TO: HEARINGS OFFICER

SUBJECT: CLASS 2 WILLAMETTE GREENWAY DEVELOPMENT PERMIT AND
TENTATIVE REPLAT CASE NO. WGP-REP22-02
1887-1899 WATER STREET NE - 97301
AMANDA NO. 22-117086-PLN

Summary: Proposed development of a new four-family residential use within the Willamette Greenway Overlay Zone, and a lot line consolidation.

PROPOSED LOT CONSOLIDATION

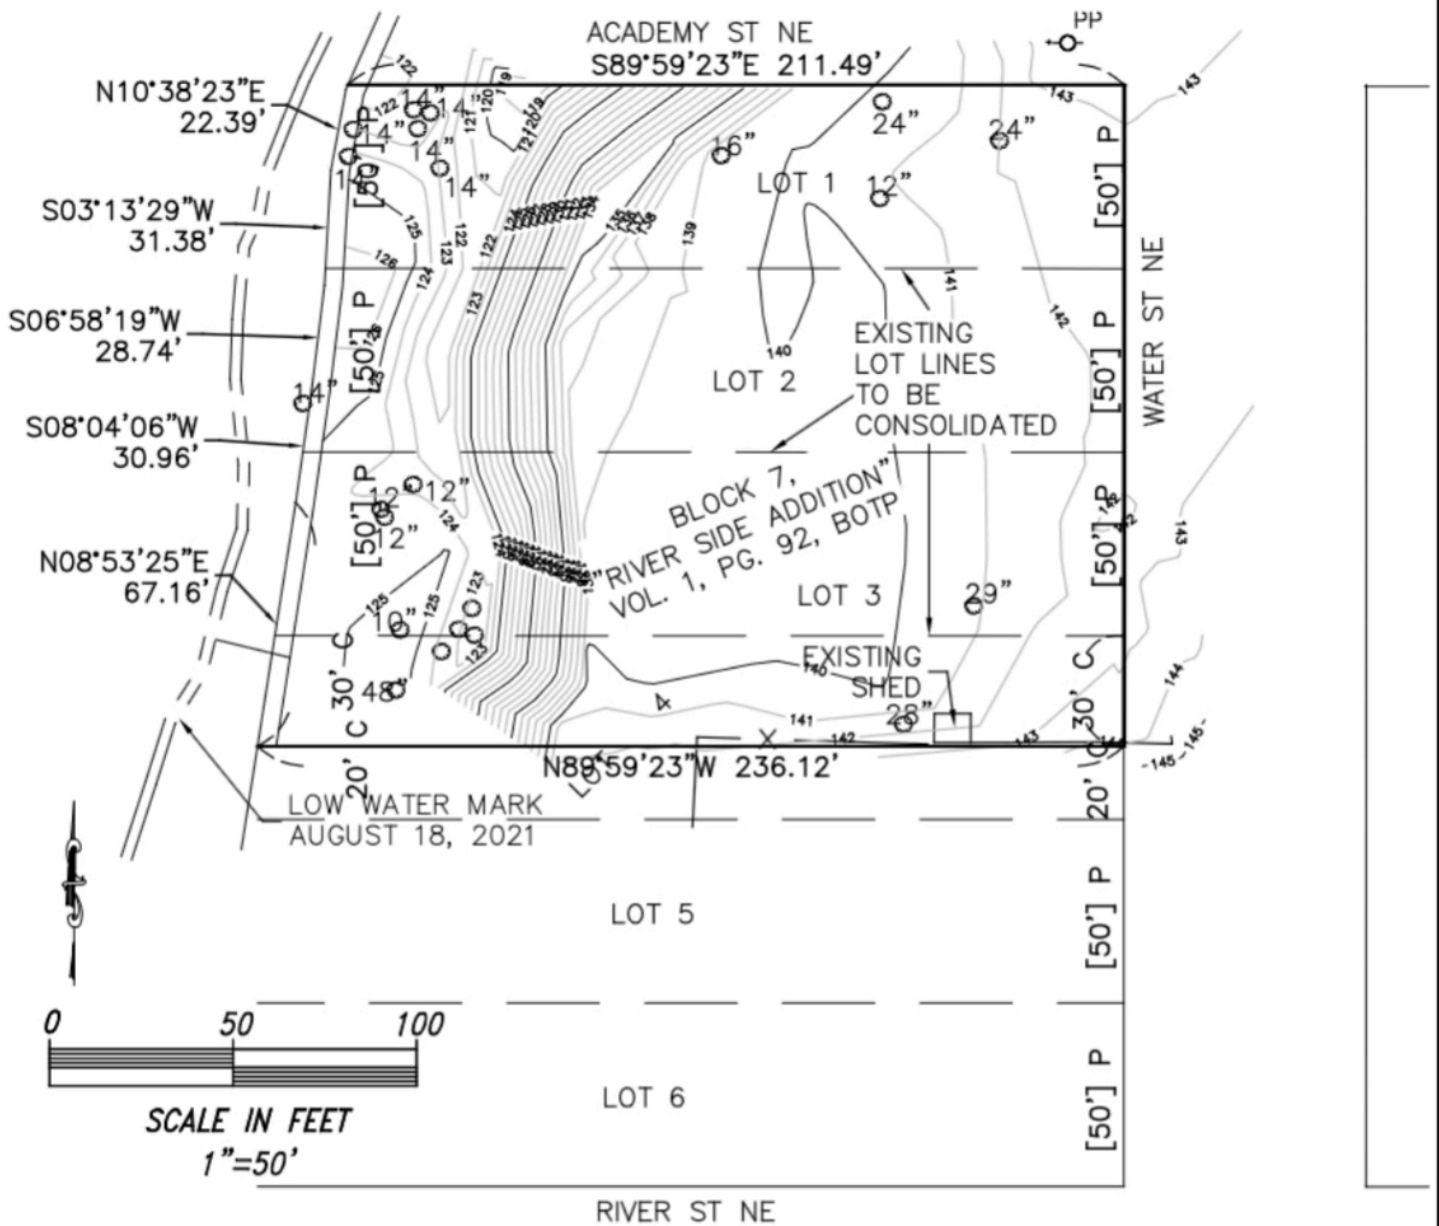
Finding: The Public Works Department has reviewed the applicant's preliminary plan for this site. The water, sewer, and storm infrastructure are existing, and appear to be adequate to serve the proposed replat. Public streets abutting the subject property are available to provide adequate street access. The applicant shall ensure relocated property lines coincide with future driveway locations and do not create conflicts with existing utility poles, cable boxes, fire hydrants, etc.

Condition 7: Relocate utilities that may obstruct future driveways or provide a site plan demonstrating that no such obstructions exist.

Condition 8: Show all existing and proposed easements on the final plat.

FRONT ELEVATION
SCALE 1/4" = 1'0" 1881 WATER STREET

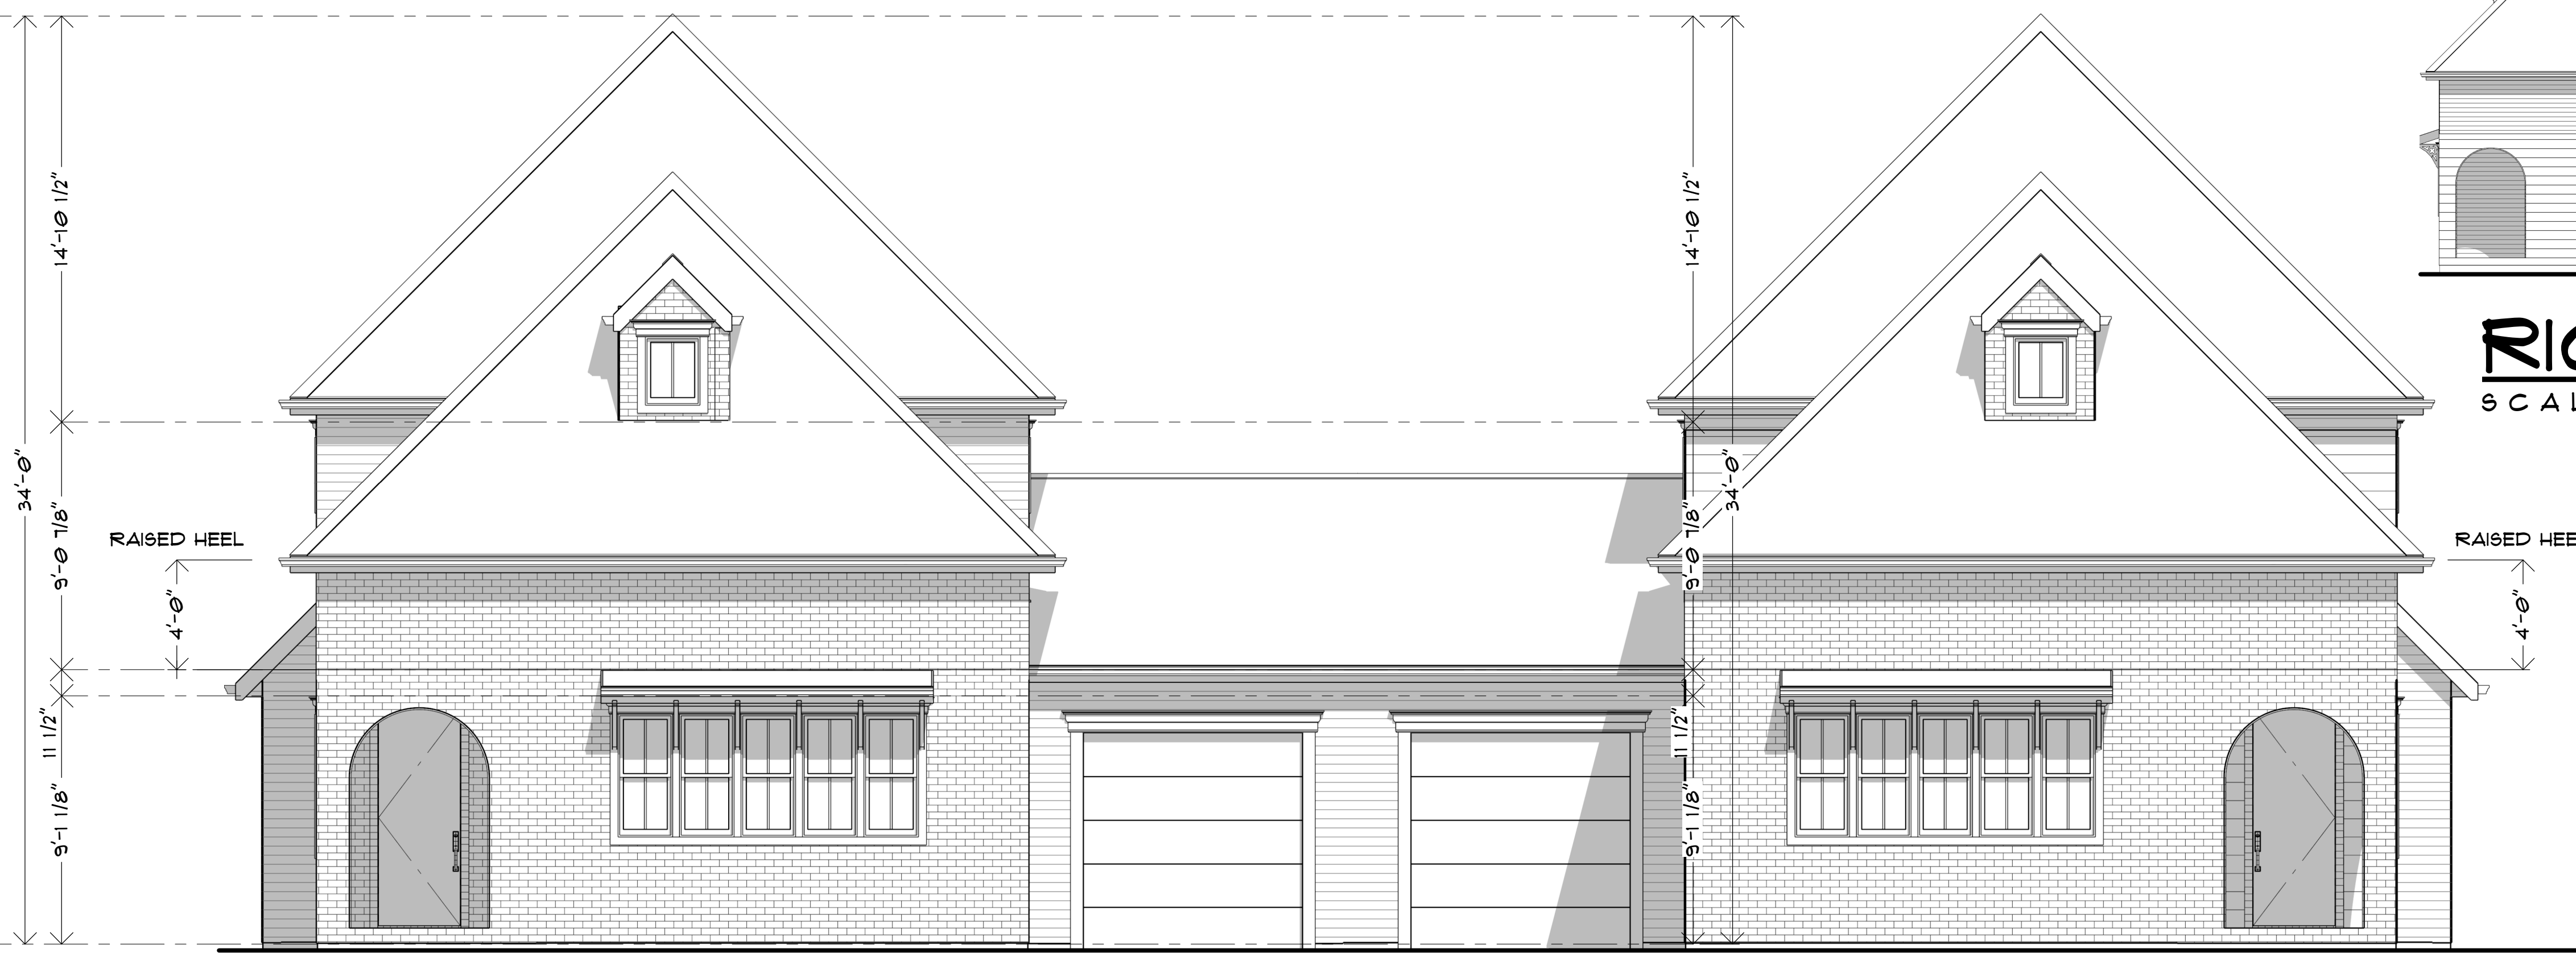
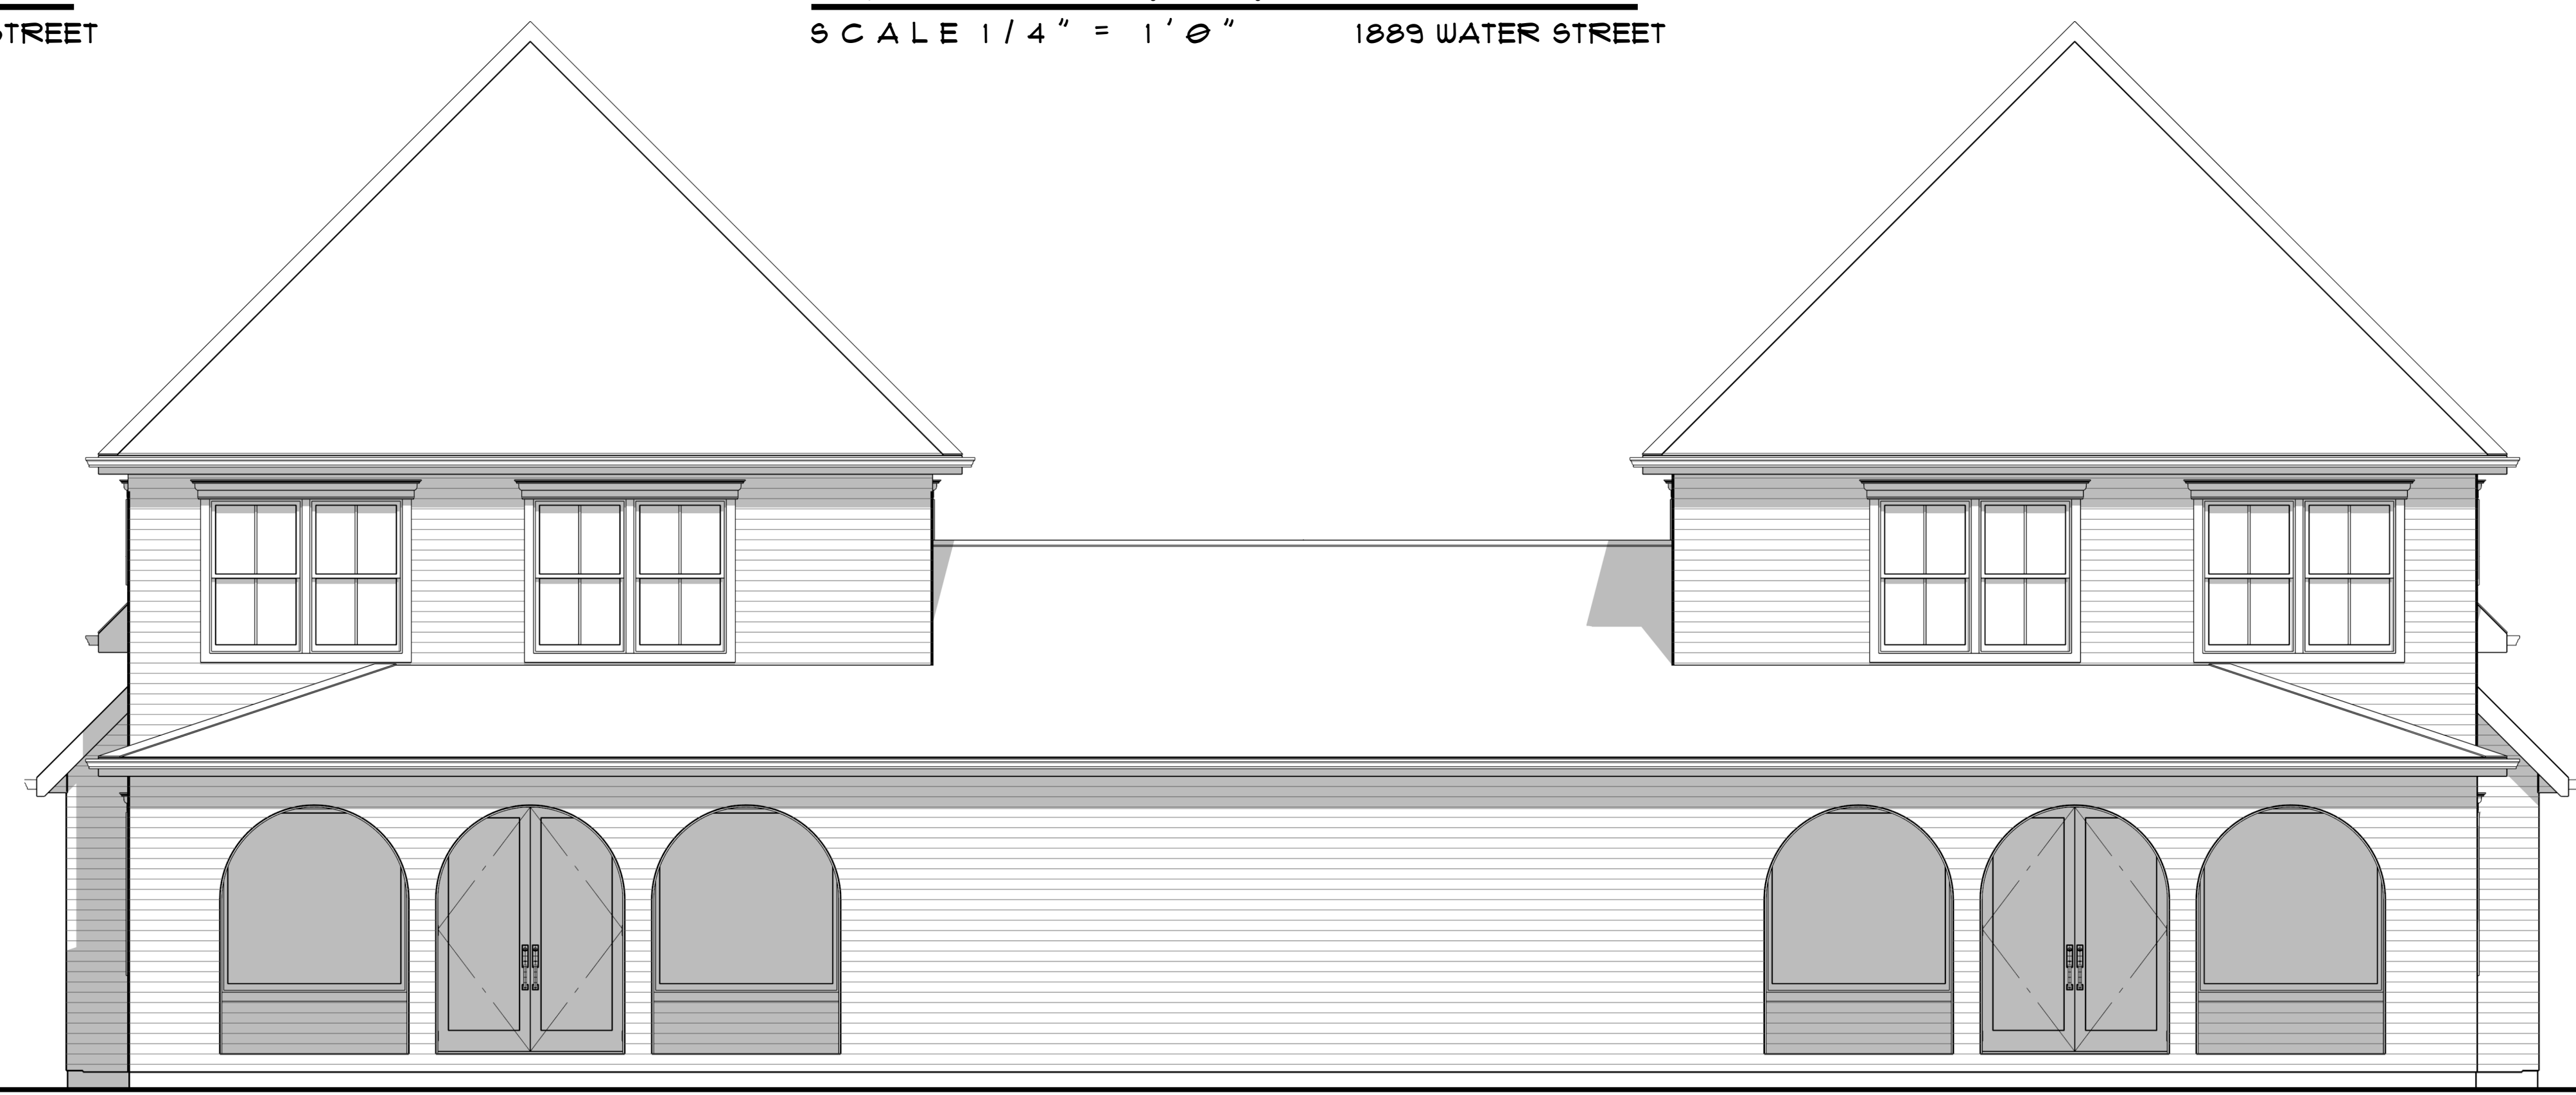
The proposed white paint color for the buildings is not a natural earth or leaf tone color that blends with the natural environment. Staff recommends that the Hearings Officer adopt a condition of approval requiring the applicant to select an alternative color within the green or brown color palette that is more appropriate for the natural environment.

Condition 2: The applicant shall select a paint color for the proposed buildings that is within the green or brown color palette.
